S.S. "Baron Elbank"
Greenock Report No. 9727.
STEEL MASTS & YARD
S. S. No 101.

DRAWING No 1133.
SCALE 1/4 INCH TO A FOOT.

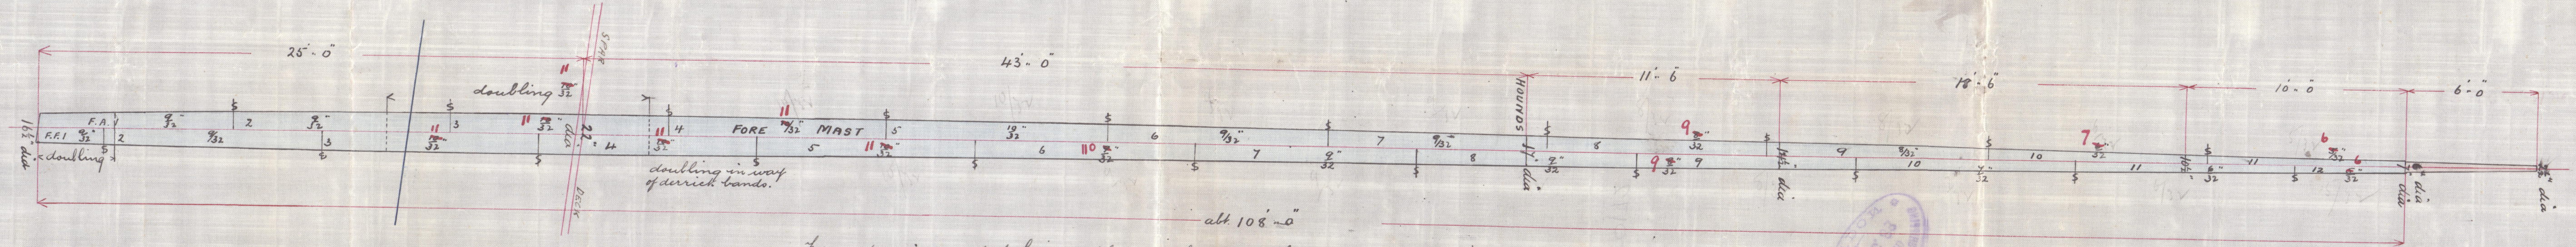
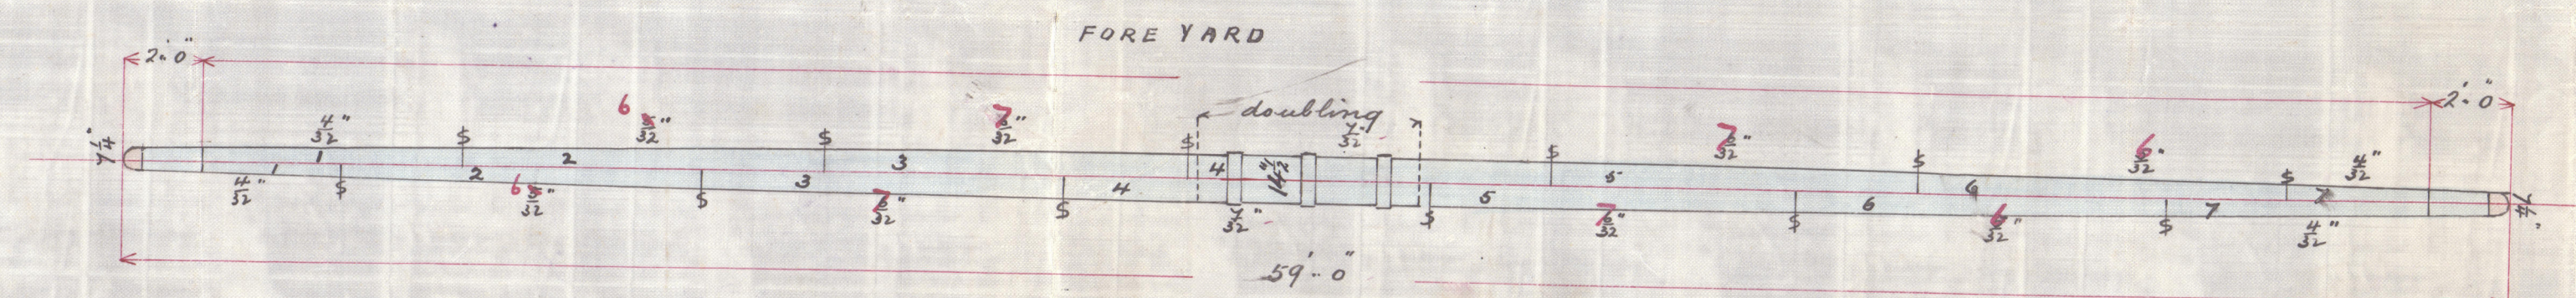
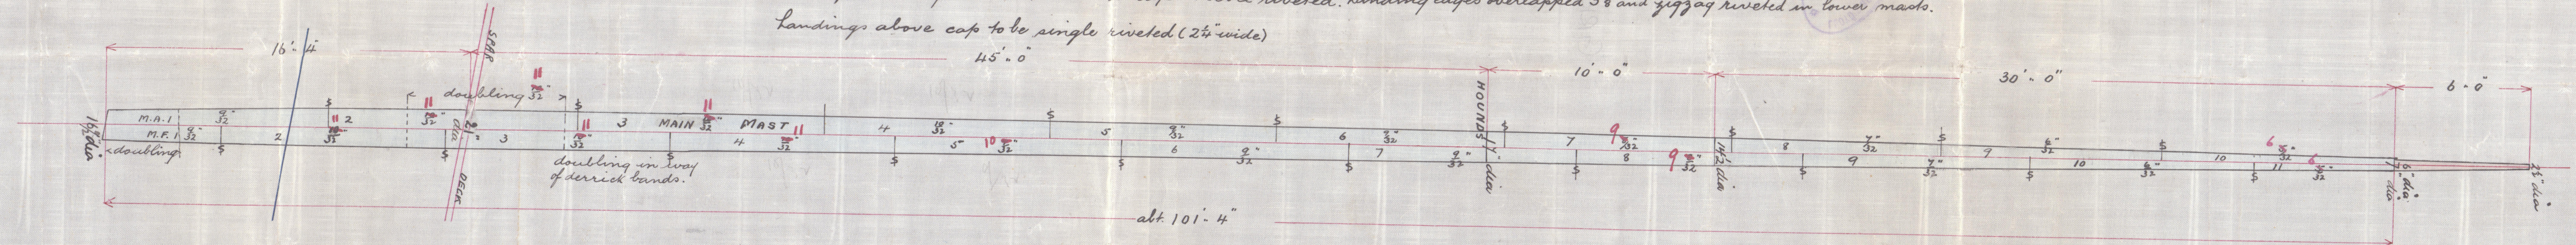
Steel plates to be efficiently strengthened

Fore and main masts to have 2 plates in the round, butt straps 1/2" thicker than the plates they connect. Butt straps treble riveted. Landing edges overlapped 3 3/8" and zigzag riveted in lower masts.
Landings above cap to be single riveted (2 1/4" wide)
